## ADDENDUM NO. 1

Re: **Bedford CSD**  
**Phase 1B – Bond Improvements**  
**Fox Lane High School**  
**SED No. 66-01-02-06-0-003-022**  
**Fox Lane Middle School**  
**SED No. 66-01-02-06-0-007-012**  
**Mount Kisco Elementary School**  
**SED No. 66-01-02-06-0-006-016**  
**Bedford Hills Elementary School**  
**SED No. 66-01-02-06-0-004-021**  
**Our File No. 22-225**

Addendum No. 1 – Bedford CSD Phase 1B Bond Improvements at the Fox Lane High School, Fox Lane Middle School, Mount Kisco Elementary School, and Bedford Hills Elementary.

**A8.03 MKES**

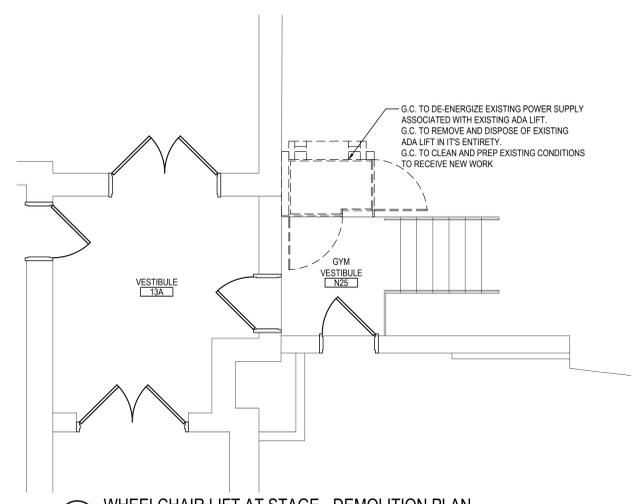
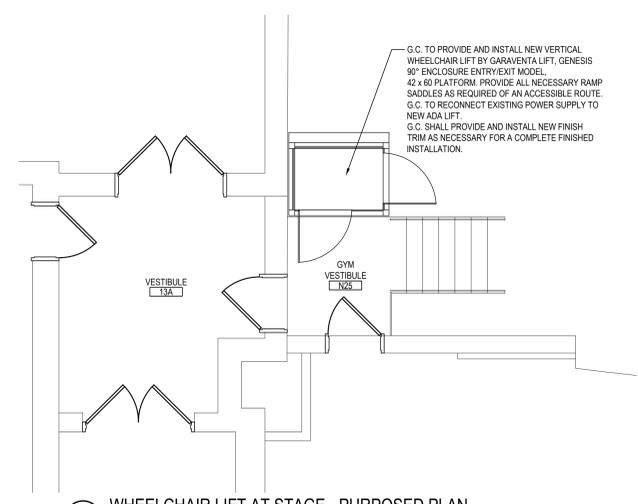
If lead-based paint is encountered, the contractor is responsible for complying with specification 029000.”
2. **Drawing A1.02 – Fox Lane Middle School – Second Floor Abatement & Demolition Plan**
  - a. The drawing attached to this Addendum shall replace the one within the Bid Documents.
3. **Drawing A2.02 – Fox Lane Middle School – Typical Classroom**
  - a. At “Typical Classroom Demolition Plan” portion of note referencing abatement of existing flooring tile under existing casework shall be removed. Existing Flooring shall be removed as standard demolition procedures.
4. **Drawing A8.03 – Mount Kisco Elementary School – Wheelchair Lift Demolition & Proposed Plans**
  - a. The drawings attached to this addendum shall be added to the Bid Documents.
